**DATE:** July 26, 2024  
**PAGE:** 1 of 16 (INCLUDING THIS PAGE)  
**TO:** ALL CONTRACTORS  
**FROM:** DENISE KING  
**PROJECT:** NEW LOXLEY WATER TREATMENT PLANT  
FOR THE CITY OF LOXLEY  
GMC PROJECT NO. CMOB220078(2)  
**RE:** ADDENDUM #3

# ADDENDUM NUMBER 3

NEW LOXLEY WATER TREATMENT PLANT

- 2.1 Specification 40 71 13 – Magnetic Flow Meters has been revised and is included as an attachment to this addendum.
- 2.2 Drawings E-912, E-913, I-101 & I-601 have been revised and are included as an attachment to this addendum.

E-913

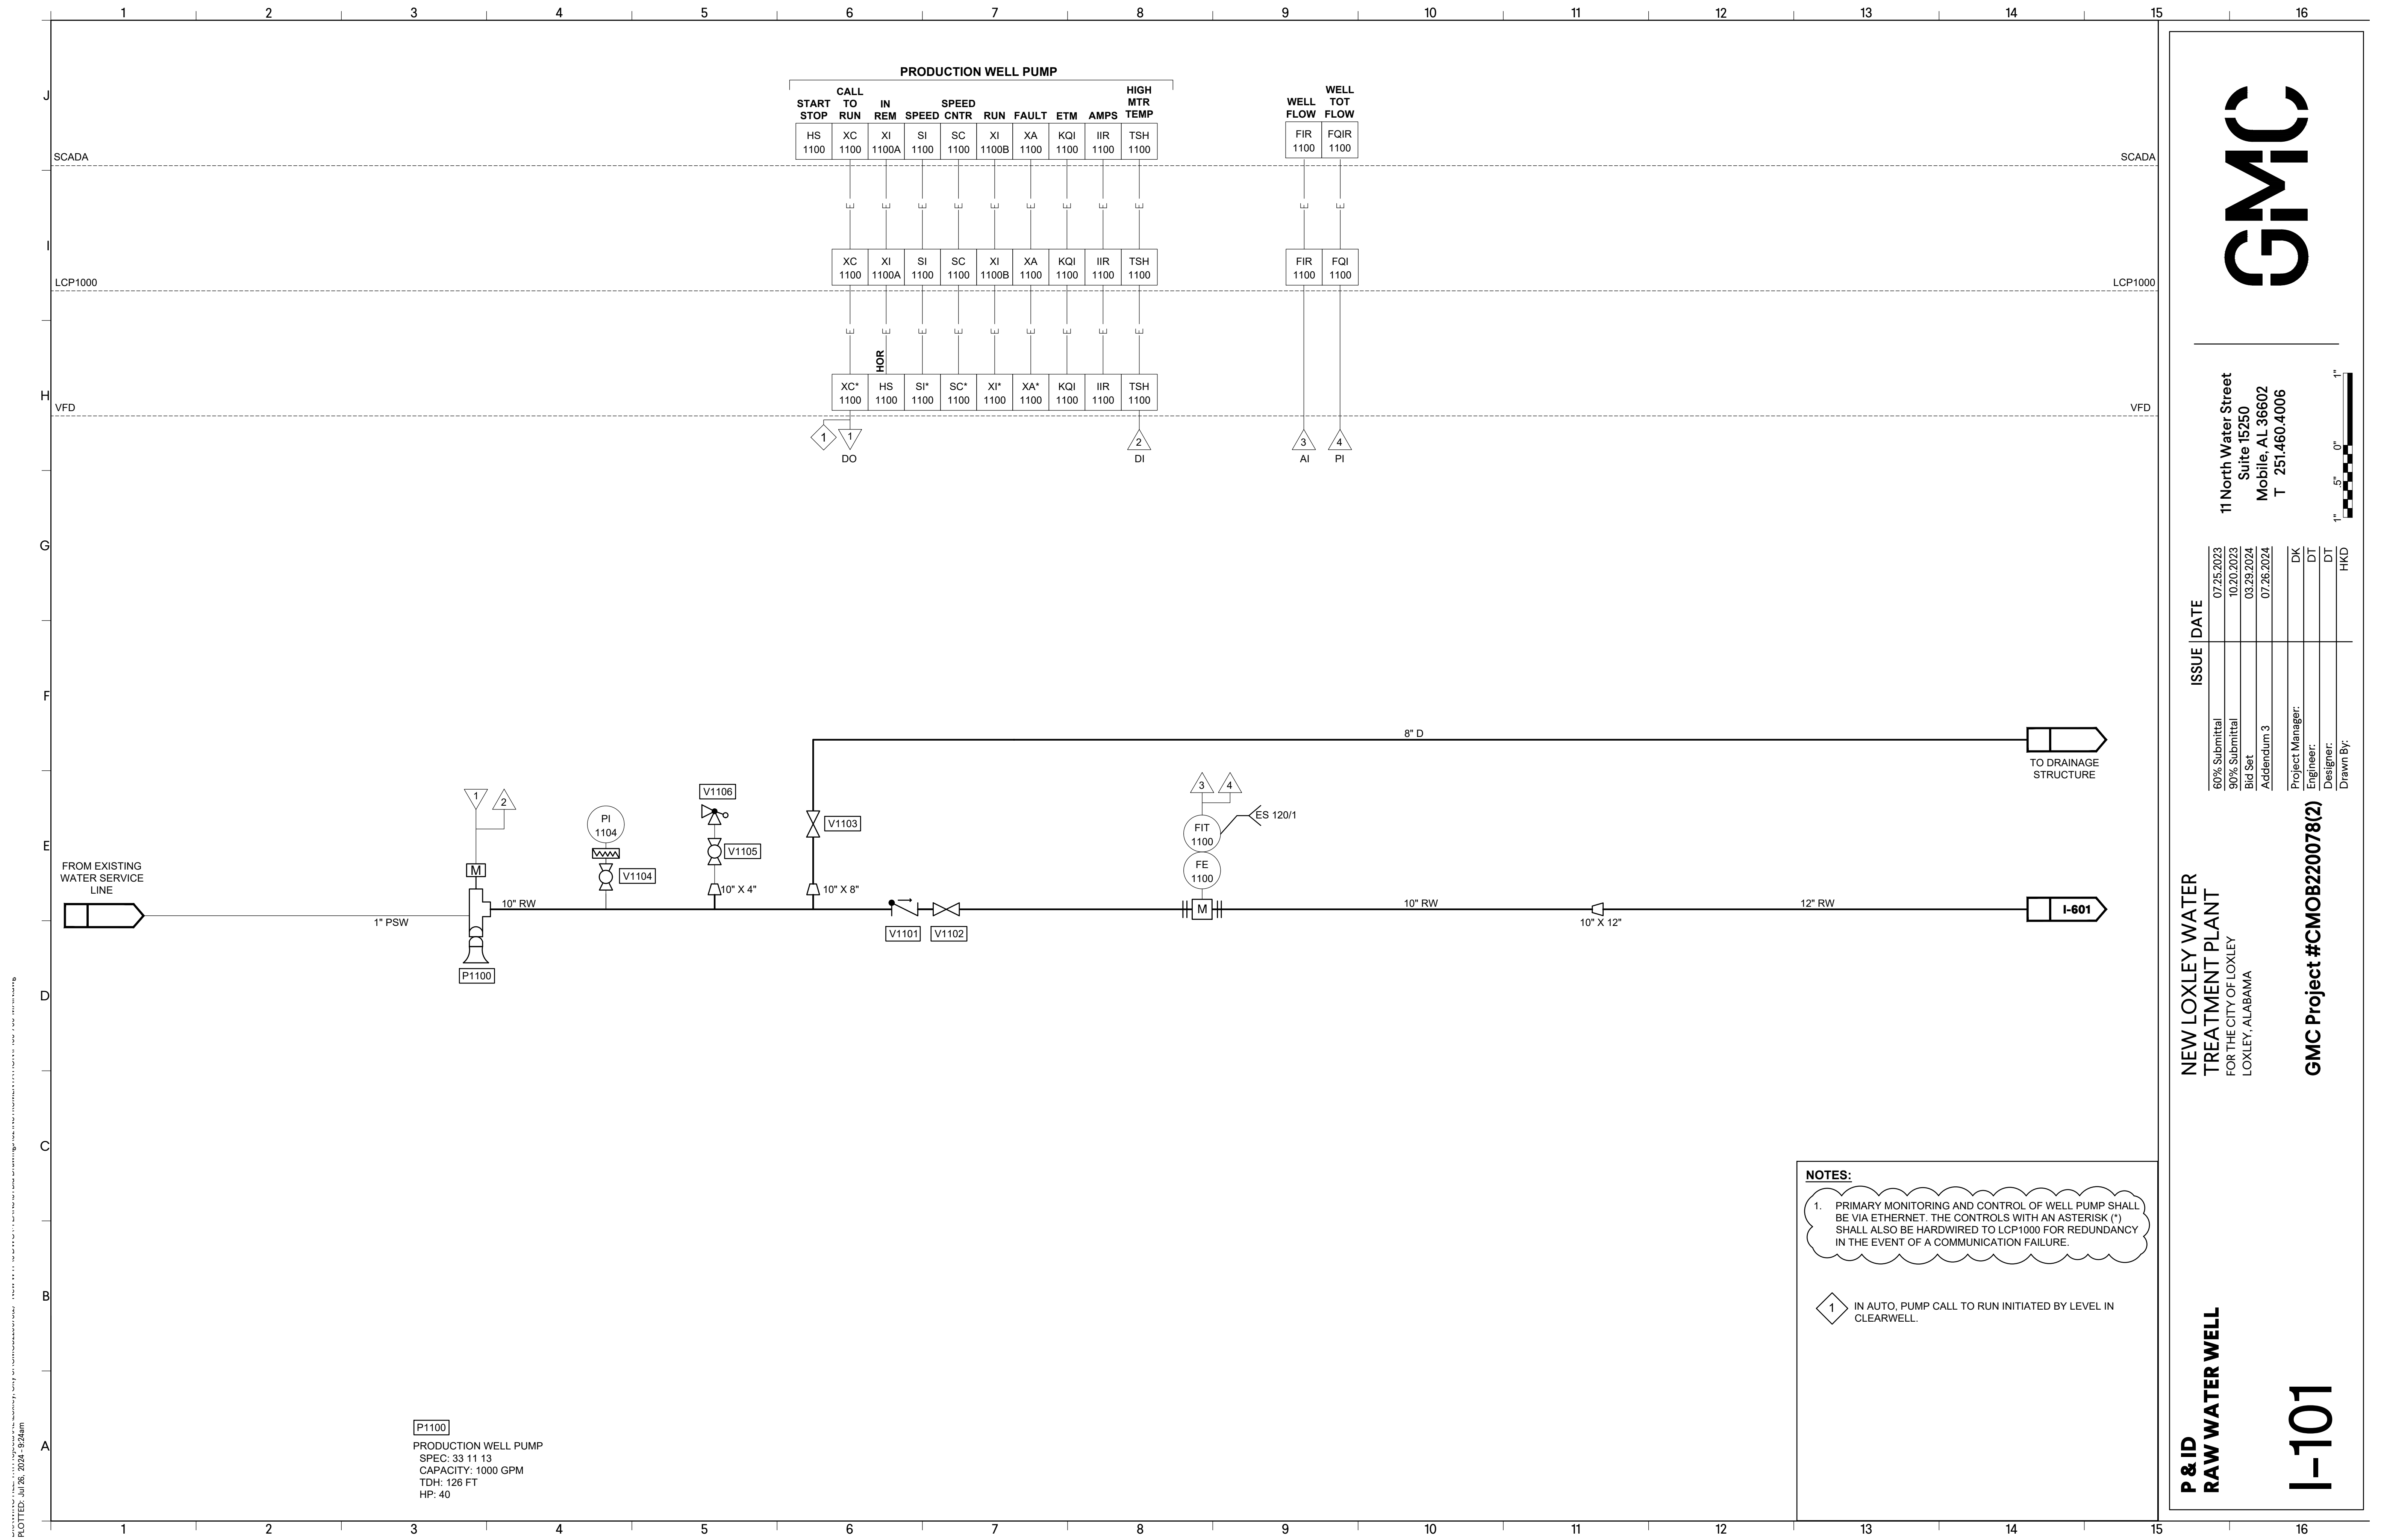
**3.8 Question: On Project Plans SHT I-811, the Chlorine Feed System is called out to receive a raw water flow signal. How is this accomplished?**

Answer: An analog signal from LCP1000 to the chlorine feed controller (FIC8110) is shown on the riser diagram on E-913 to flow pace the chlorine feed system.

1. PRIMARY MONITORING AND CONTROL OF WELL PUMP SHALL BE VIA ETHERNET. THE CONTROLS WITH AN ASTERISK (\*) SHALL ALSO BE HARDWIRED TO LCP1000 FOR REDUNDANCY IN THE EVENT OF A COMMUNICATION FAILURE.

I-101

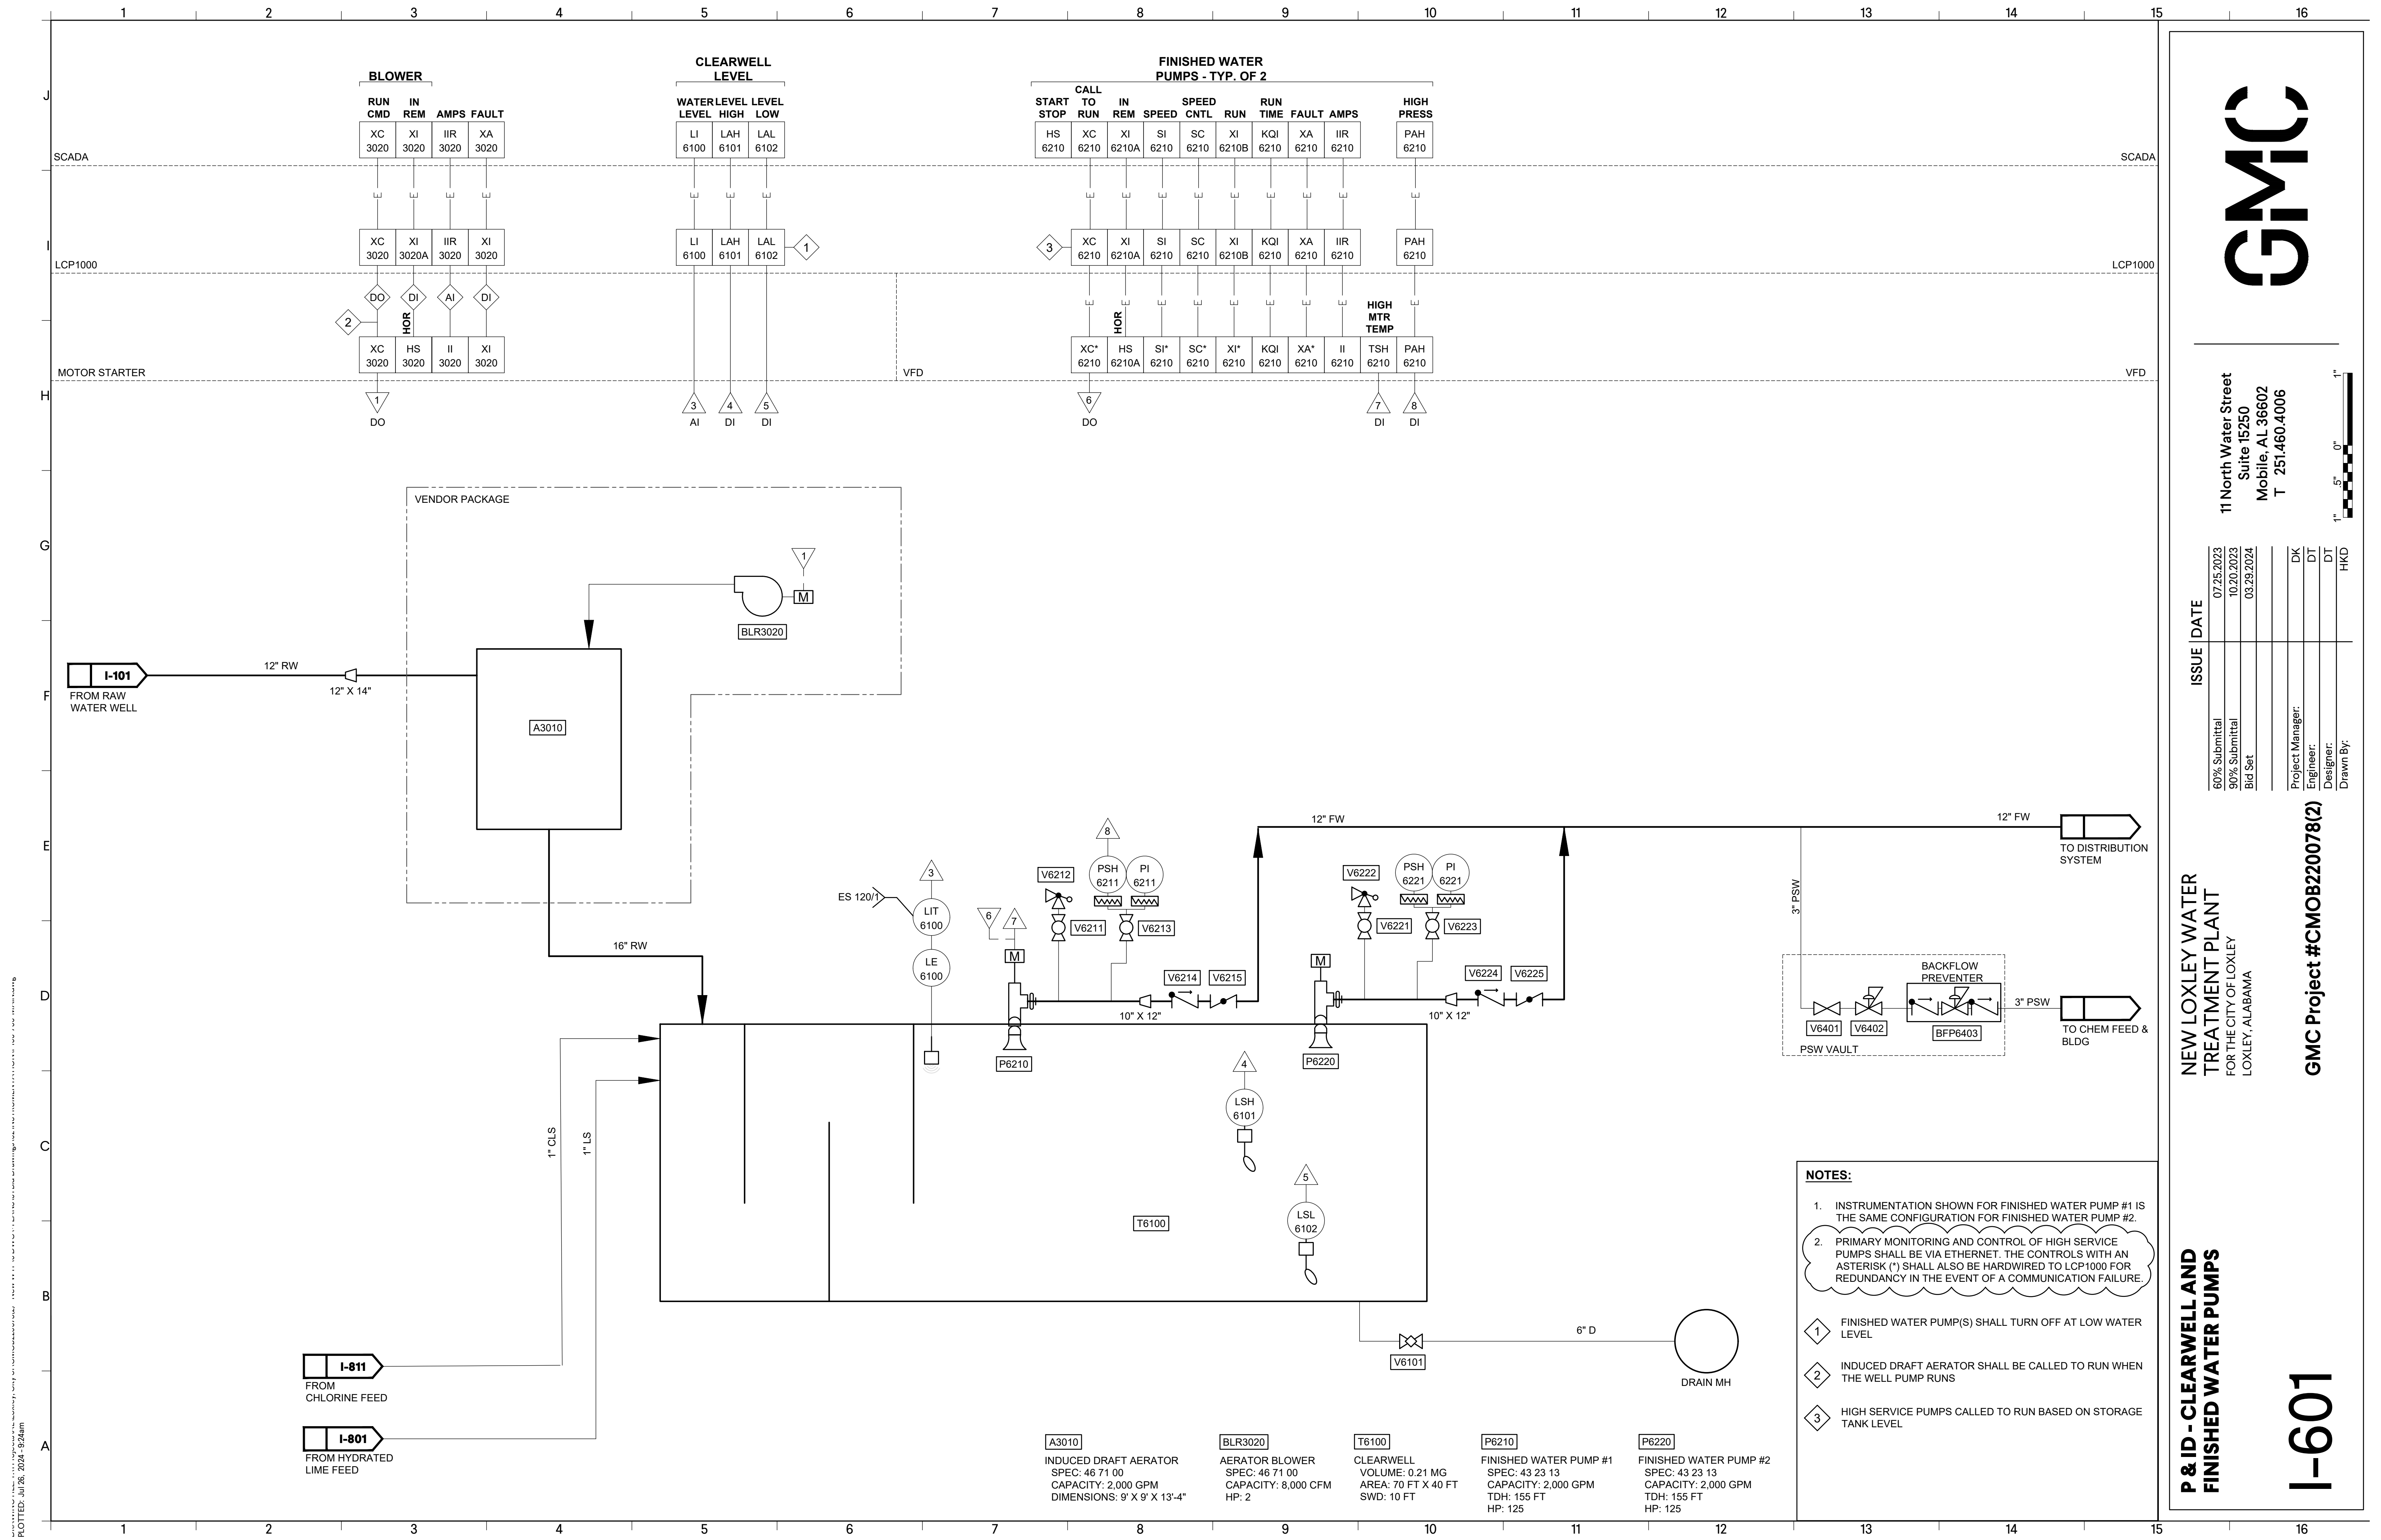
Answer: Yes, Specifications 40 73 36 & 40 73 63 apply to these pressure switches.
- 3.3 **Question: PI1104 on SHT I-101, PI6211 on SHT I-601, & PI6221 on SHT I-601 are not listed in the specifications. Please confirm that Specification 40 73 13 & 40 73 63 apply to these instruments.**

- 3.7 **Question: Project Plans SHT I-101 and I-102 show that Well VFD and Finished Water VFDs are to be monitored and controlled via ethernet only. With critical equipment it is advantageous to supply**

**hardwired connections in the event of a communication failure of any kind to still have monitoring and control over the motor. Please clarify intention to control if communication failure occurs.**

Answer: Yes, Specification 40 73 13 & 40 73 63 apply to these instruments.
- 3.4 **Question: PI8003 on SHT I-801 & PI8103 on SHT I-811 are not listed in the specifications. Please confirm that specification 40 73 13 applies to these instruments**

Answer: Revised electrical and P&ID drawings are included as an attachment to this addendum showing hardwired connections for VFDs for redundancy. Primary monitoring and control shall be via ethernet.
